SERVICE BULLETIN

ENGINE – PROVIDE A NEW CARBON SEAL FOR THE NO.5 BEARING COMPARTMENT – CATEGORY CODE 6
– MOD.ENG-72-0142

V2500-ENG-72-0142

Reidentification of the Seal Components
Fig.1

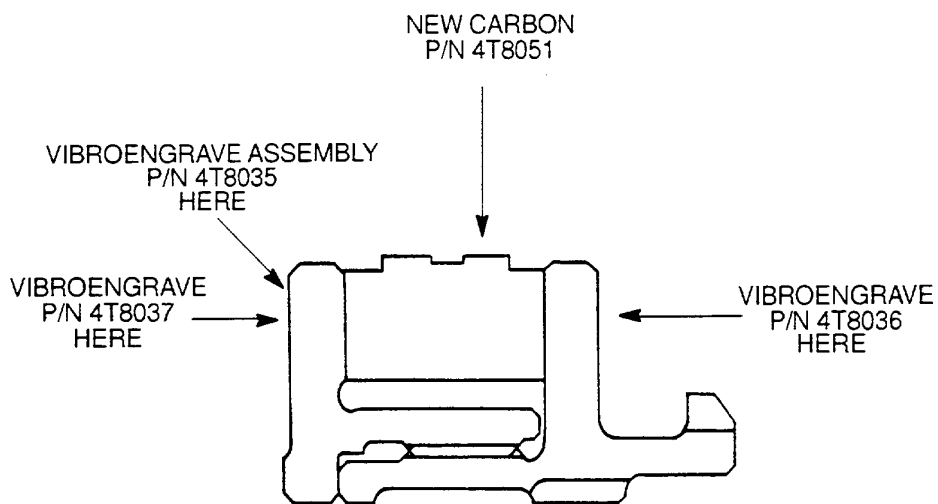
The wave spring and the loading rings have been deleted.

The two carbon pieces have been replaced by one bigger carbon piece.

The old seal assembly can be disassembled to allow incorporation of the new carbon piece using the existing spacers.

- (1) Install the carbon seal assembly P/N 4T8002 on the holder of IAE 1F10439. Make sure that the holes on the seal spacer engage the pins on the holder.

- (2) Install the wrench of IAE 1F10439 on the seal assembly. Make sure that the wrench engage the slots on the seal spacer.
- (3) Turn the wrench counterclockwise until the spacer is fully disengaged. Remove the wrench and the spacer.

- (4) Scrap the carbon rings, the loading rings and the wave spring. Retain the spacers.
- (5) Clean the spacers as specified in the SPM TASK 70-11-22.
- (6) Mark the new part number on the spacers as shown in figure. Use a vibropeen. Remove high metal.

- (7) Do again step (1).
- (8) Install the new carbon ring P/N 4T8051.
- (9) Install the wrench on the spacer. Make sure that the wrench engage the slots on the spacer. Turn manually clockwise the wrench.

- (10) Fully seat the spacers. Torque to 26 to 95 lbfin (2,94 to 10,79 Nm),
- (11) Renumber the carbon seal assembly
 - (a) Cancel the P/N 4T8002 electrochemical etched. use a vibropeen.

- (b) Vibroengrave the new assembly P/N 4T8035 adjacent to cancelled one.
 - (c) Remove high metal.
